Date: August 6, 2025
To: Zach Torrance-Smith, Kittitas County Planning
From: Craig Jones, City Development Coordinator *CJ*
Through: Derek Mayo, City Engineer *DKM*
Re: Plat comments for Pfenning 39 lot Plat LP25-00004

The following are the City Public Works comments for the proposed 39 lot Plat in the 900 blk of north Pfenning Rd.

W
A
T
E
R

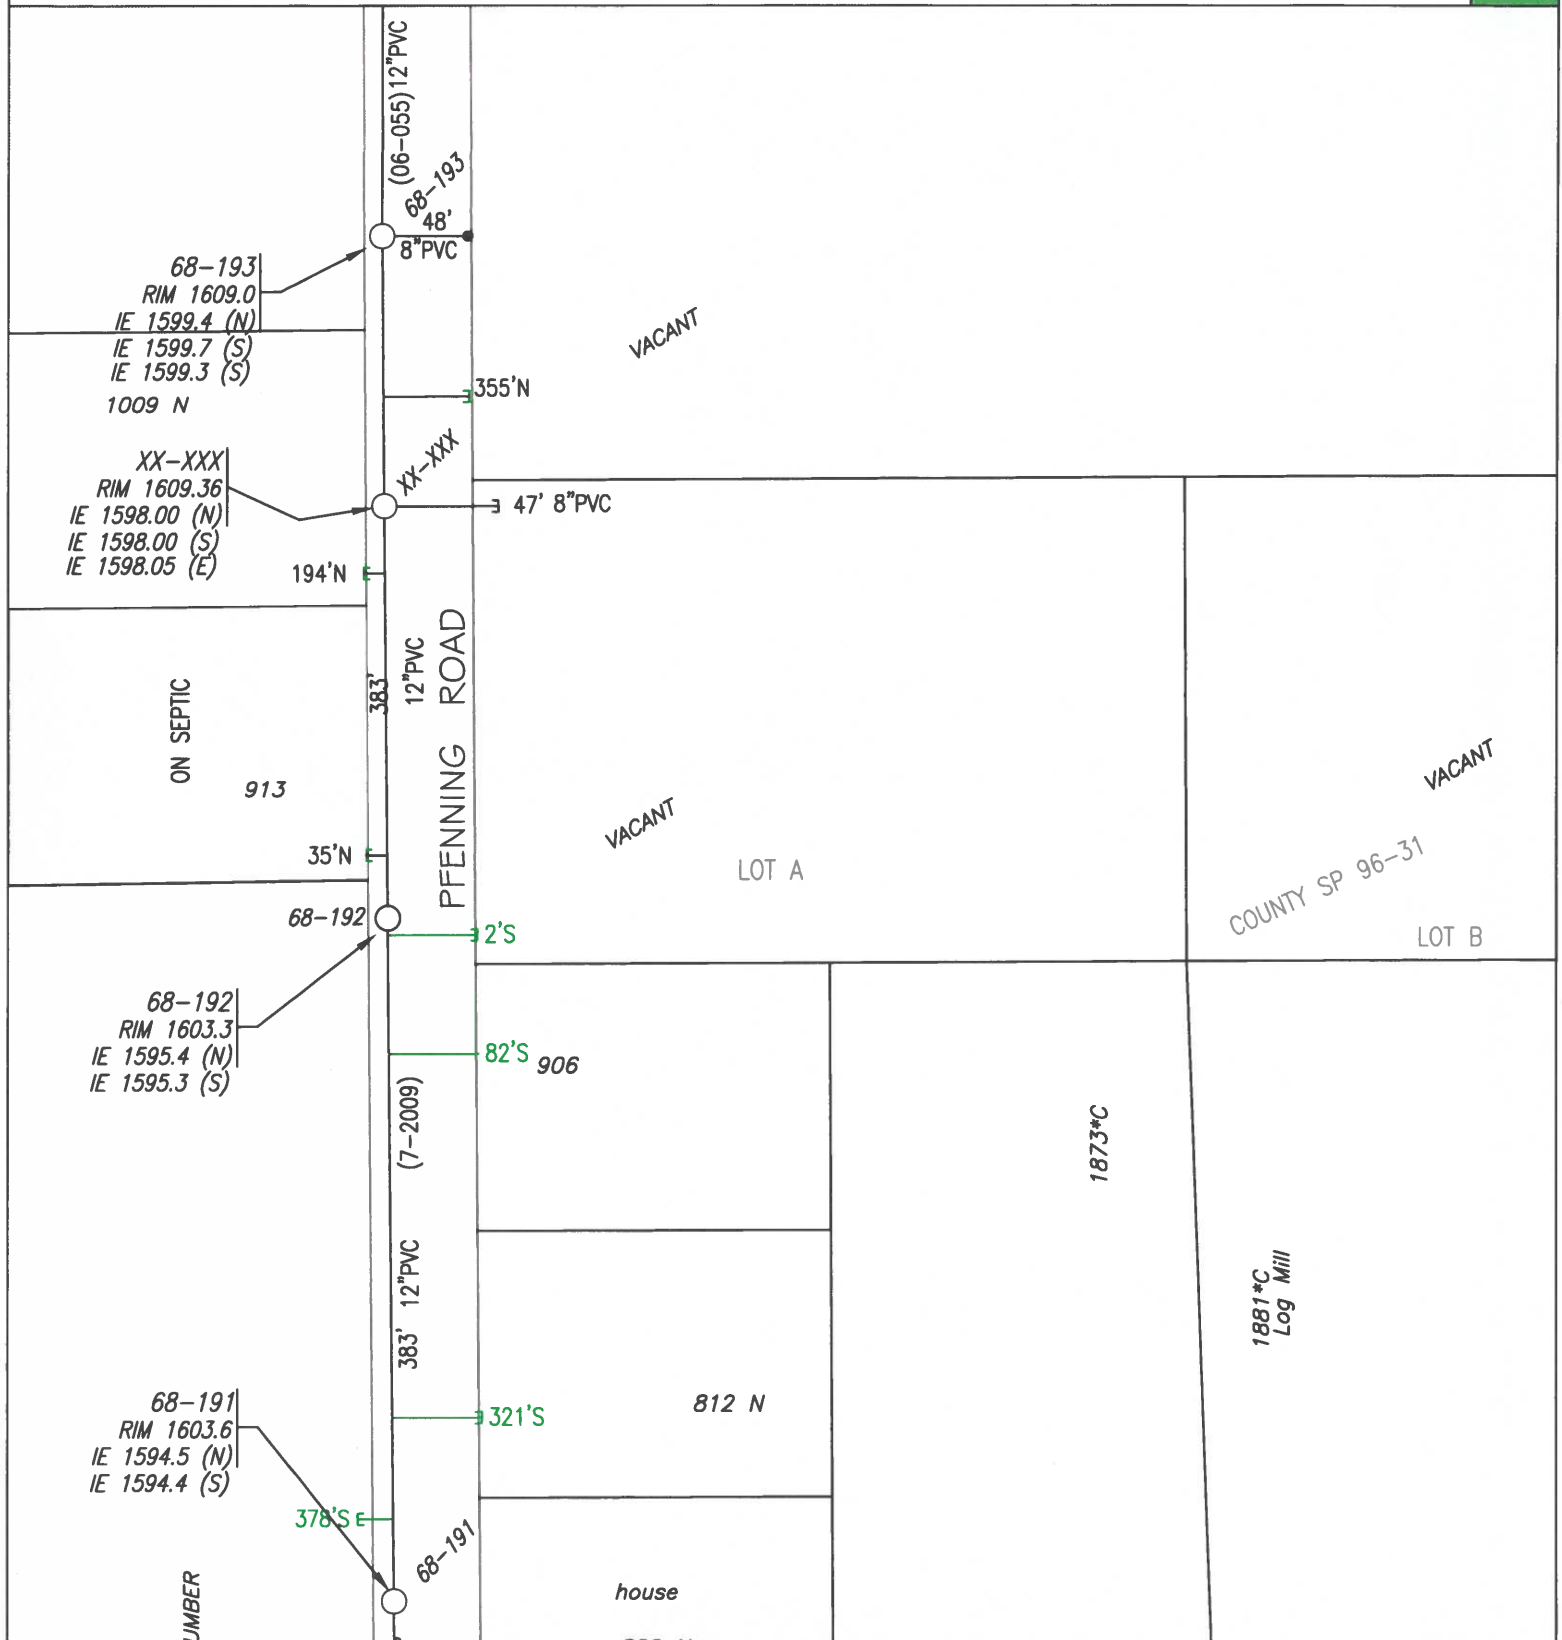
The water main available to serve this development is a 12" Ductile Iron main that runs in Pfenning Rd. There is an 8" existing stub in the proximity of the proposed access road. The developer will need to build an 8" water main on all the proposed interior roads. Each lot will need a separate water service. The maximum number of lots that can be served by one water connection is 40 lots. Larger water service lines may be required for any lot that will have a residential fire sprinkler system. Looping of an interior water main may be needed depending on fire flows. See attached utility map.

S
E
W
E
R

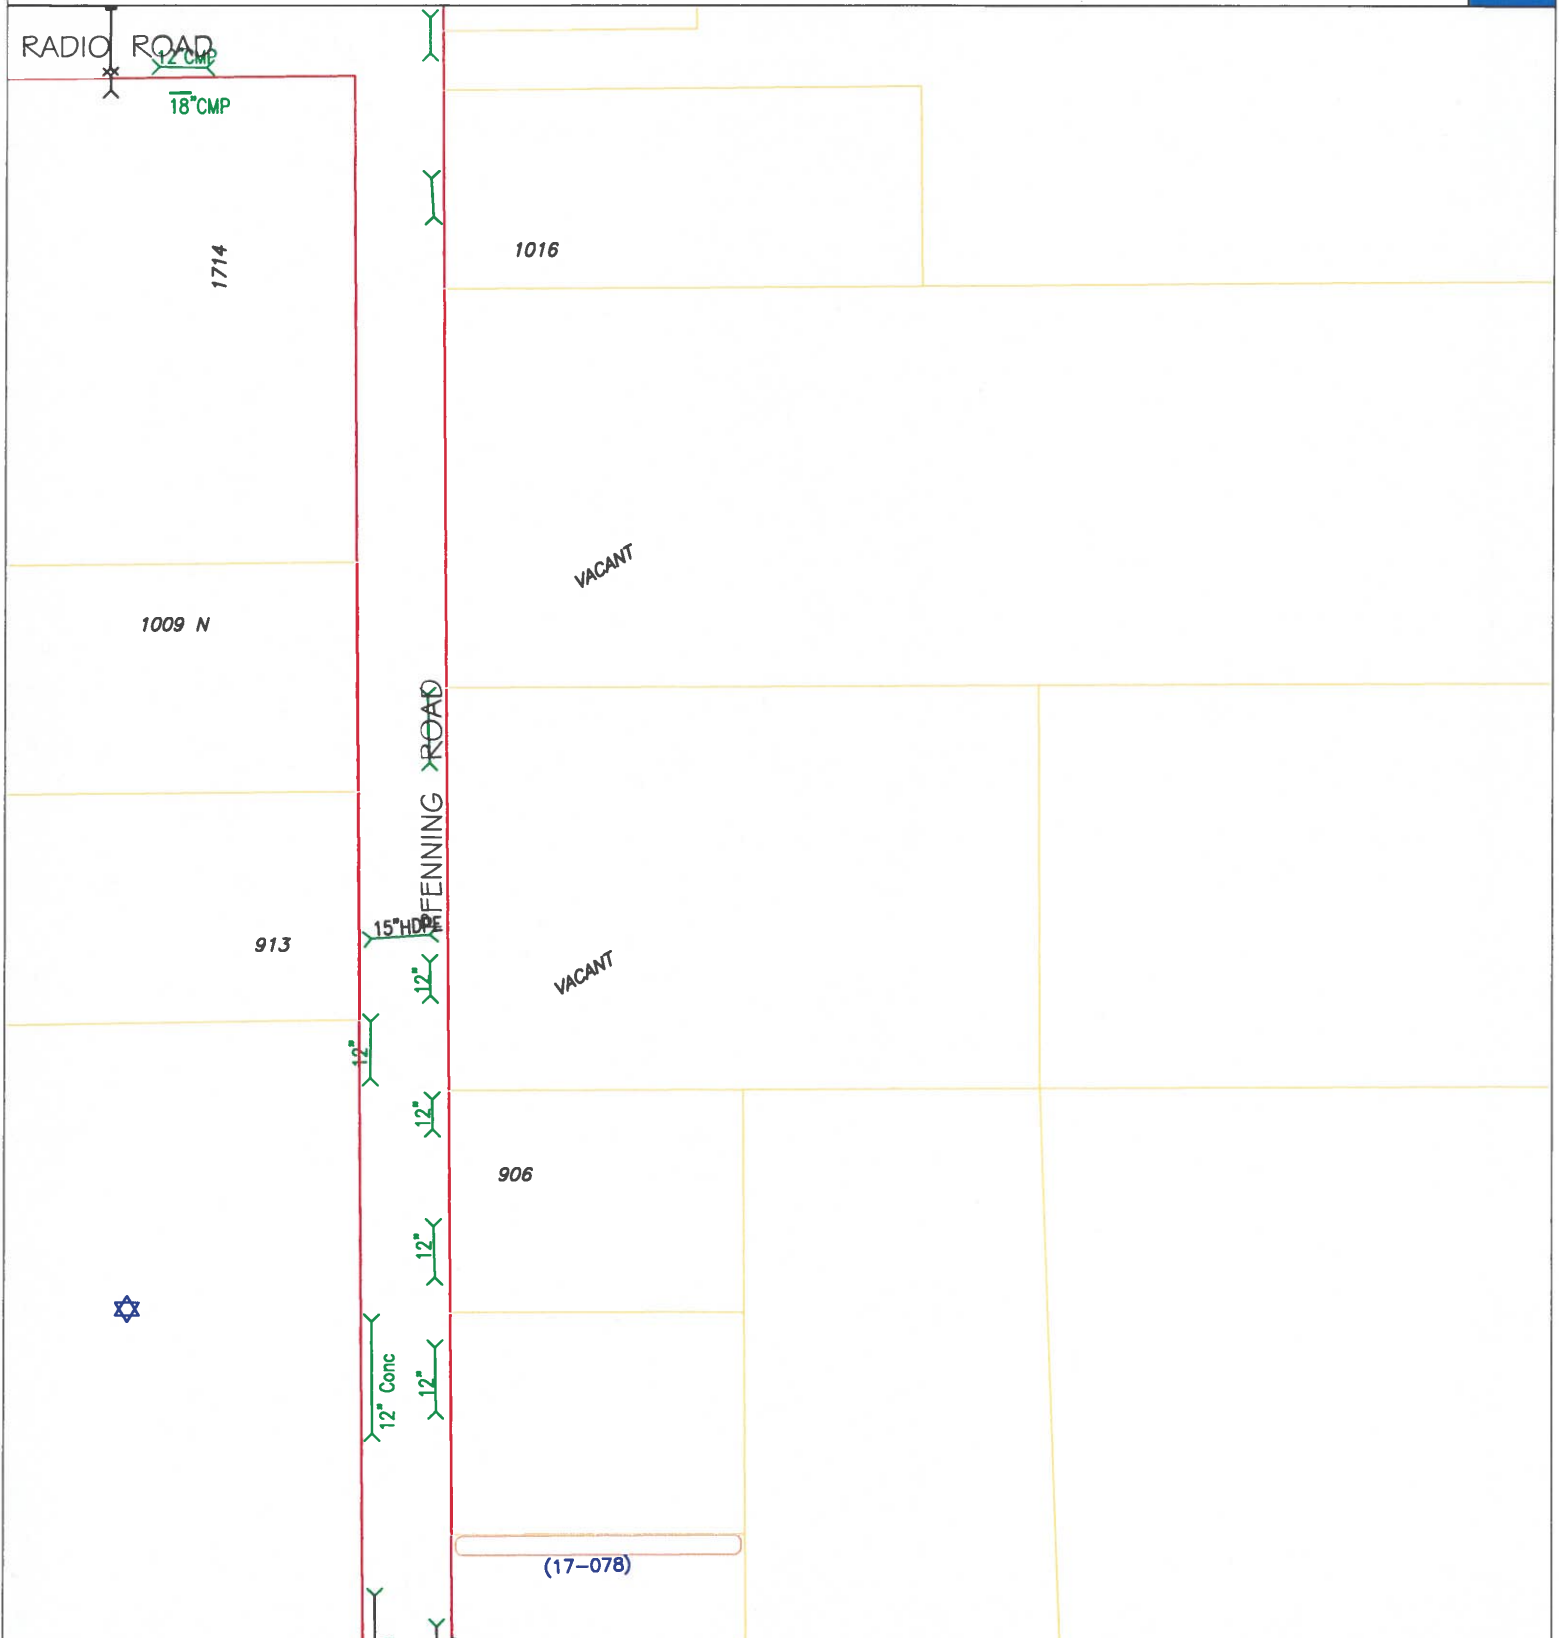
The sewer main available to serve this development is a 12" PVC main in Pfenning Rd. There is an 8" existing stub in the proximity of the proposed access road. The developer will need to install 8" sewer mains on the interior roads and side sewer stubs to each lot. See attached utility map.
